# Map Correction-Field Verification

Drain Name: Centennial South Phase 2

RE: Williams Creek Drain, Centennial South Phase 2 Arm

#### **Re: Williams Creek: Centennial South Phase 2**

Sincere

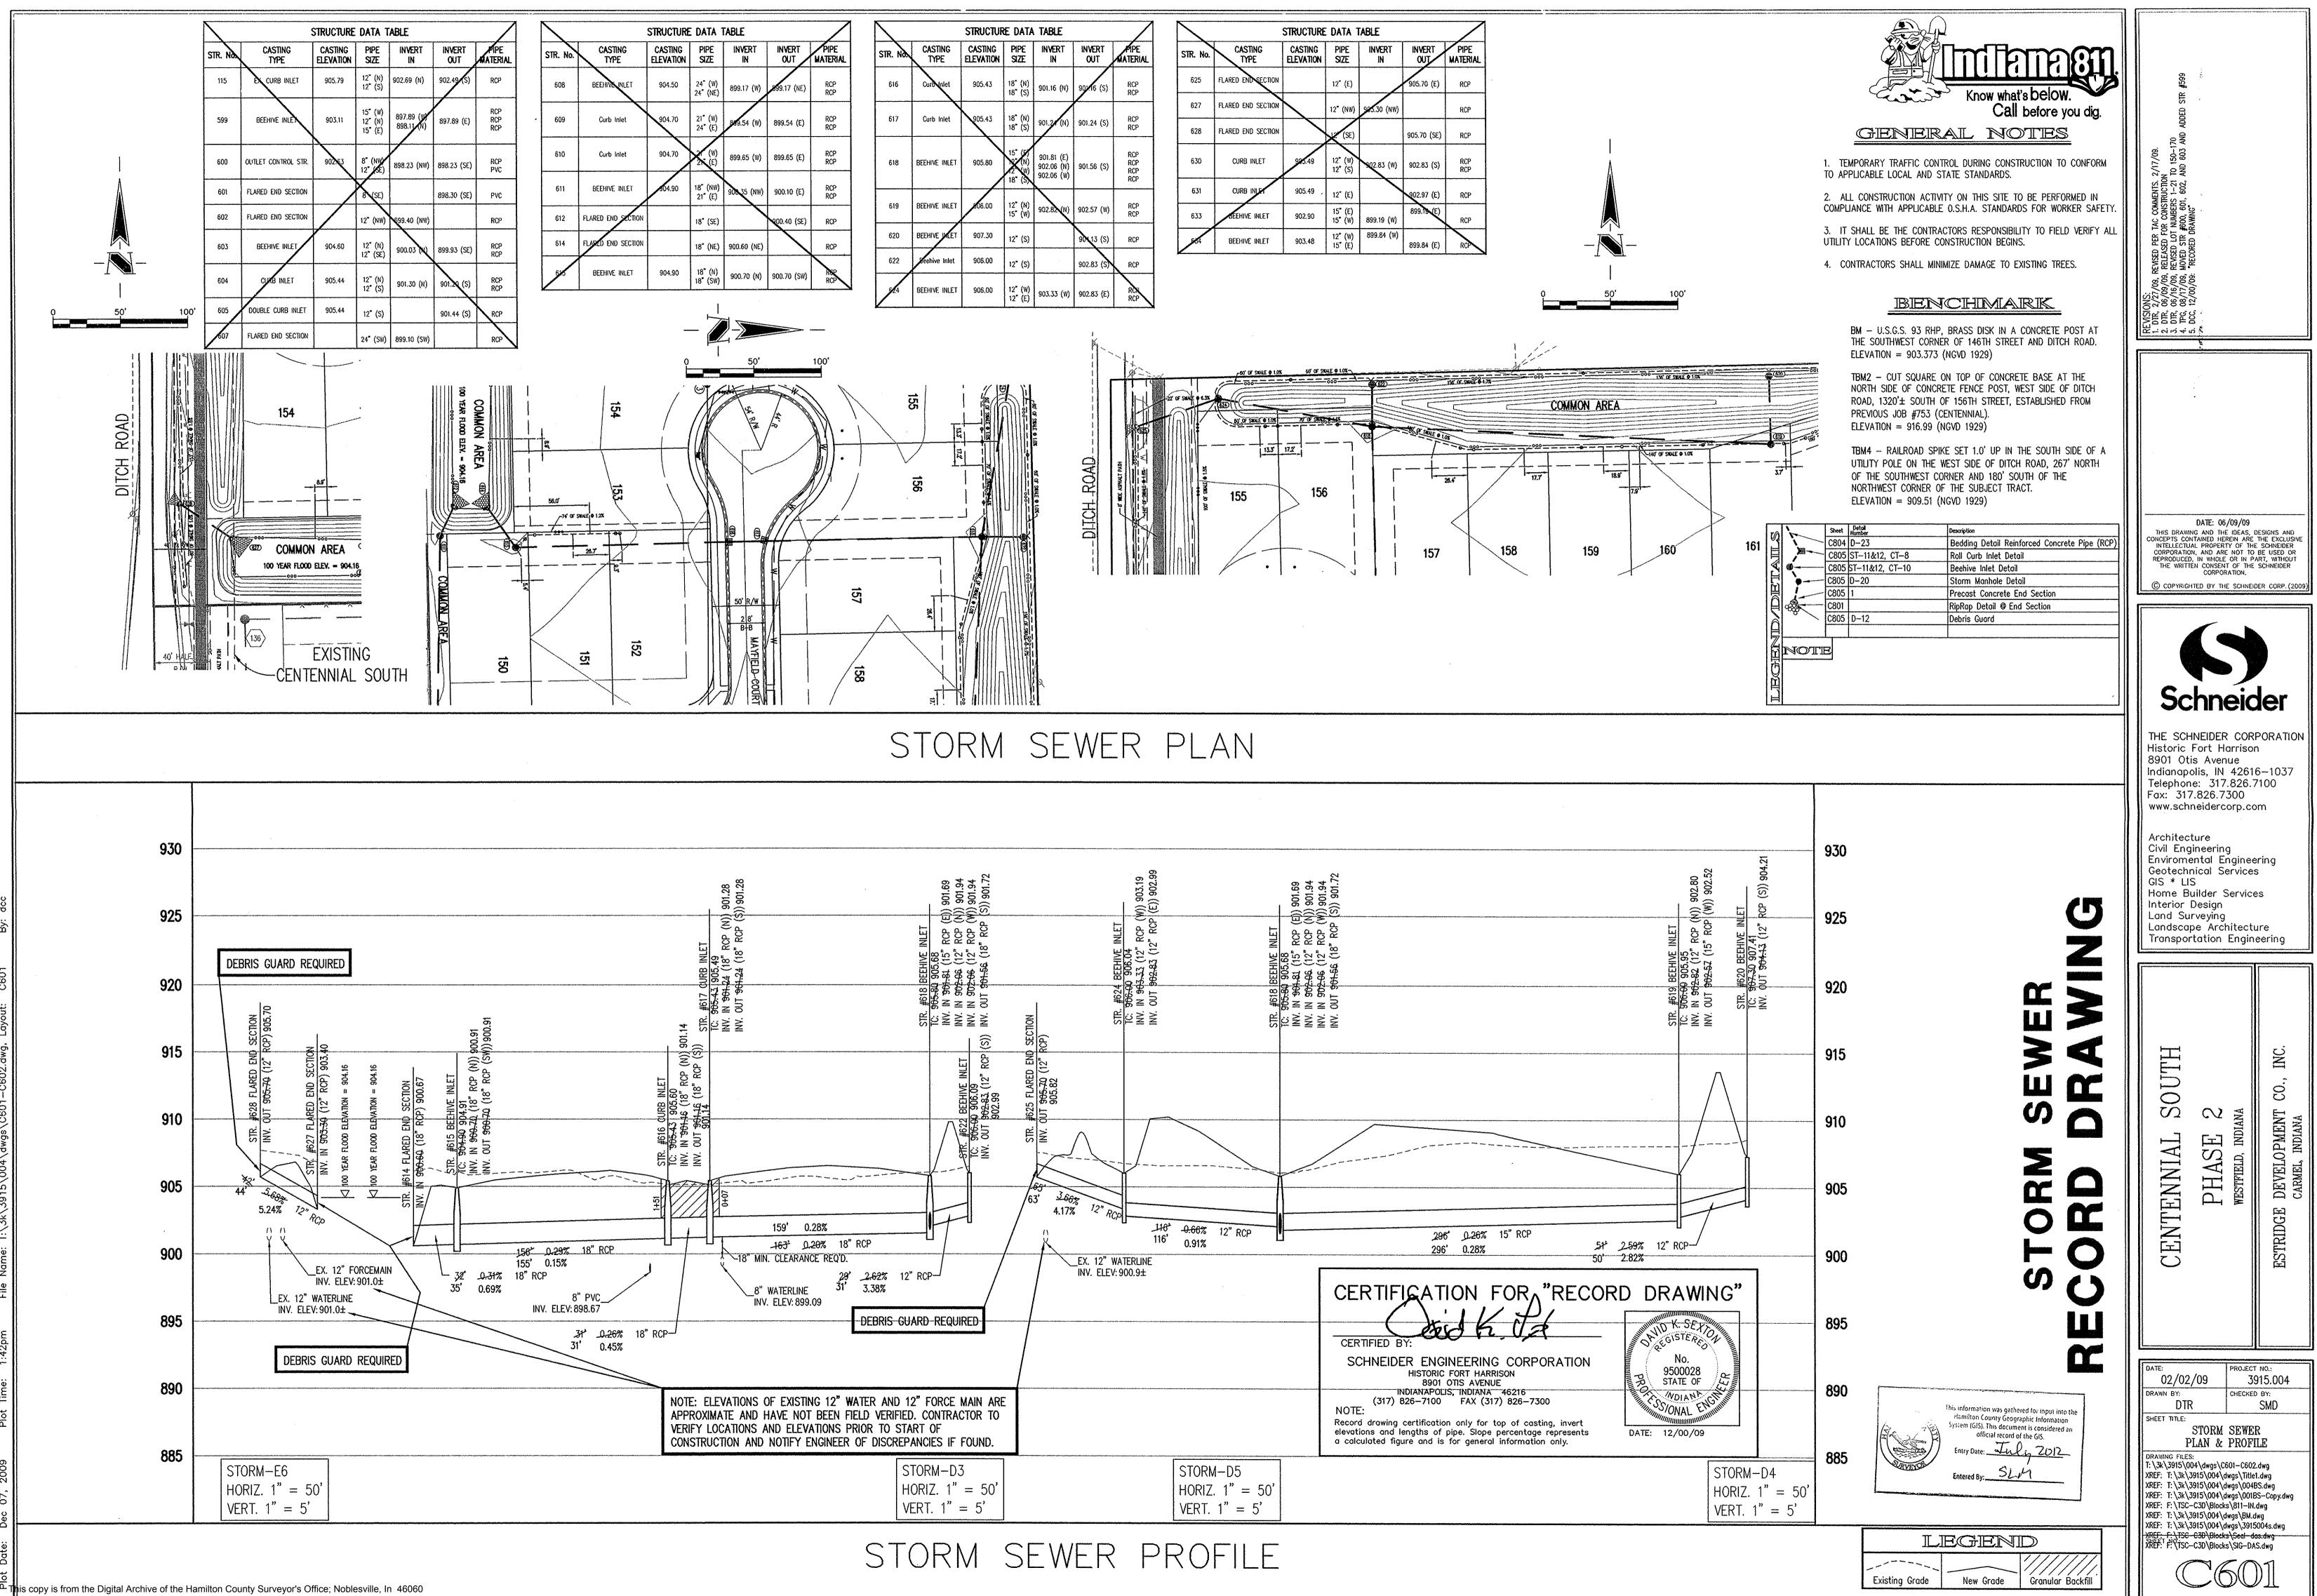
During construction, changes were made to the drain, which will alter the plans submitted with my report for this drain-dated September 1, 2009. The report was approved by the Board at the hearing held October 26, 2009. (See Drainage Board Minutes Book 12, Pages 311-312) The changes are as follows:

The 12" RCP was shortened from 623 feet to 598 feet. The 15" RCP was shortened from 388 feet to 386 feet. The 18" RCP was shortened from 406 feet to 403 feet. The 24" RCP was lengthened from 168 feet to 189 feet. The 6" SSD was lengthened from 1830 feet to 1898 feet. The length of the drain due to the changes described above is now 3,654 feet.

# Map Correction-Field Verification

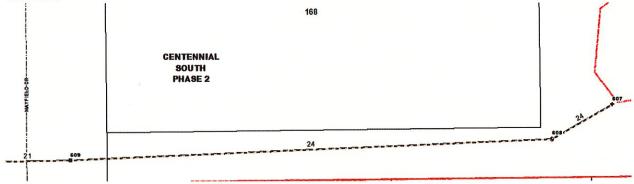
The 24" RCP was incorrectly reported on the final report. The total length of 24" RCP should be 166 feet.

New Length: 3408

Change + / - : -23
